PRAIRIE ISLAND NUCLEAR GENERATING PLANT

REQUEST FOR AMENDMENT TO
OPERATING LICENSES DPR-42 & DPR-60

LICENSE AMENDMENT REQUEST DATED May 7, 1992

Evaluation of Proposed Changes to the Technical Specifications Appendix A of Operating License DPR-42 and DPR-60

FIGURE 1

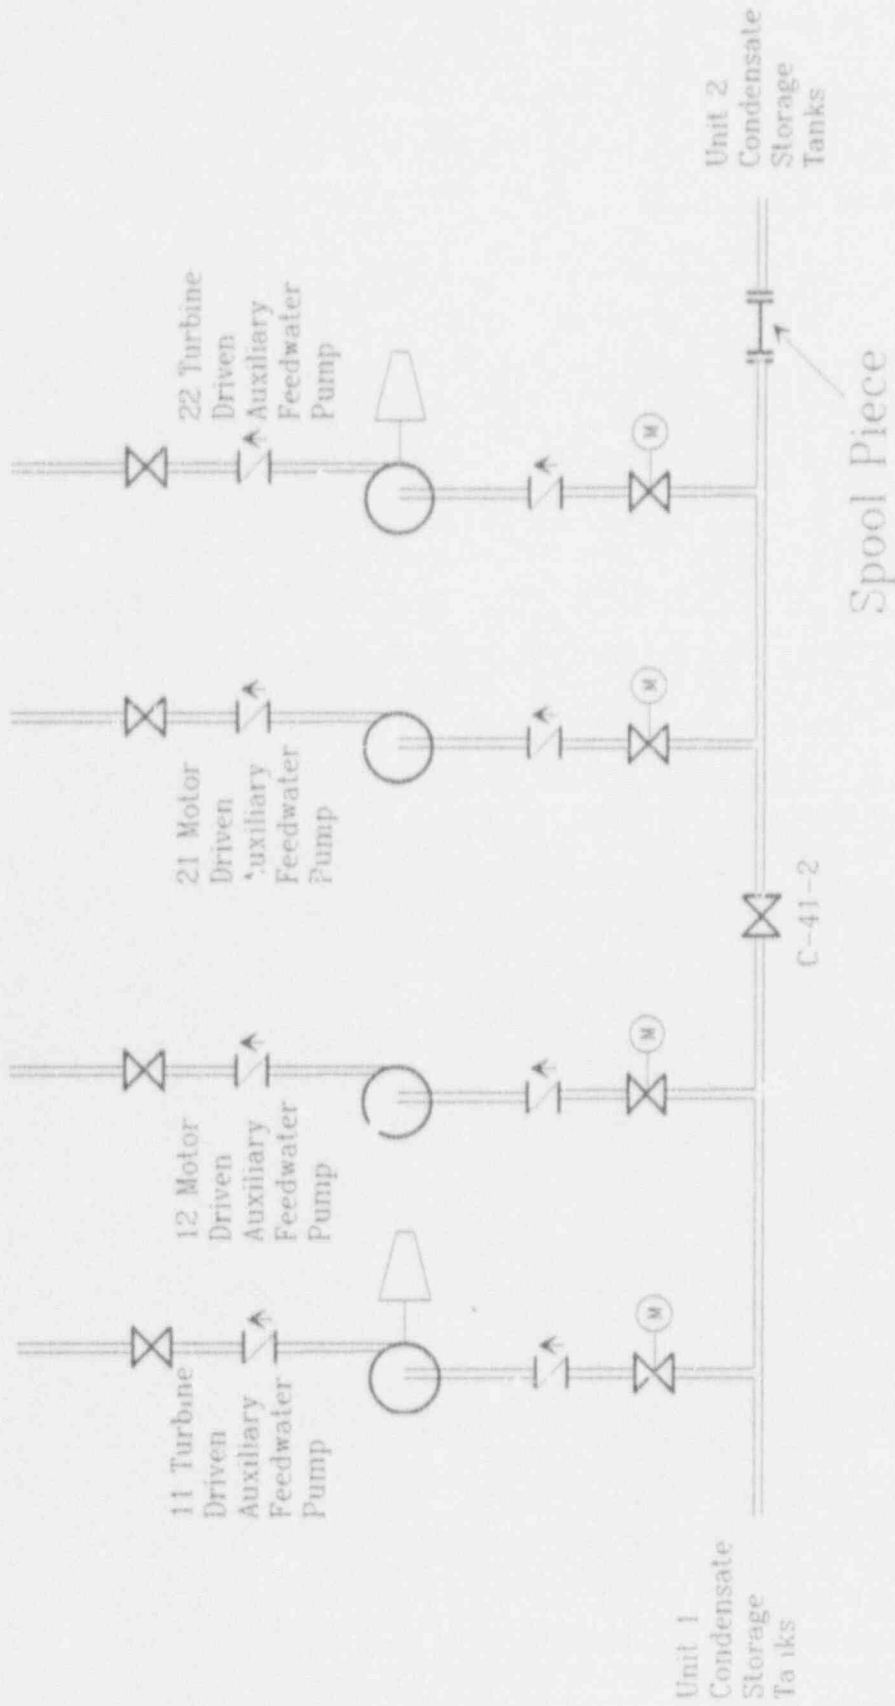
Specification 3.4.B.1.g currently specifies that condensate cross connect valves C-41-1 and C-41-2 be blocked and tagged open. A reliability study of the Prairie Island auxiliary feedwater system was completed in April 1986. That reliability study concluded that the reliability of the auxiliary feedwater system could be improved if valve C-41-1 was removed from the condensate supply to the auxiliary feedwater pumps and replaced with a spool piece (see Figure 1).

Valve C-41-1 was subsequently removed and replaced with a spool piece. However, due to an oversight, the valve was removed and replaced with a spool piece before it was removed from the Technical Specifications. Valve C-41-1 was originally included in the Technical Specifications to protect against inadvertent closure of the valve which would adversely affect the condensate supply to the auxiliary feedwater pumps. When it was identified that the valve had been removed without modifying the Technical Specifications, it was concluded that the spool piece performed the same function as a blocked and tagged open valve and that the use of the spool piece met the intent of the Technical Specification 3.4.b.1.g. Based on the reliability study discussed above, the use of the spool piece in place of the blocked and tagged valve improves the reliability of the auxiliary feedwater system and results in a plant configuration with a larger margin of safety than is provided by the current Technical Specification requirements in Section 3.4.B.1.g.

This license amendment request proposes the deletion of condensate cross connect valve C-41-1 from Prairie Island Technical Specification Section 3.4.B.1.g. The proposed changes are being made to bring the Prairie Island Technical Specifications into agreement with the actual plant configuration. The specific wording changes to the Prairie Island Technical Specifications proposed by this License Amendment Request are shown in Exhibits B and C.
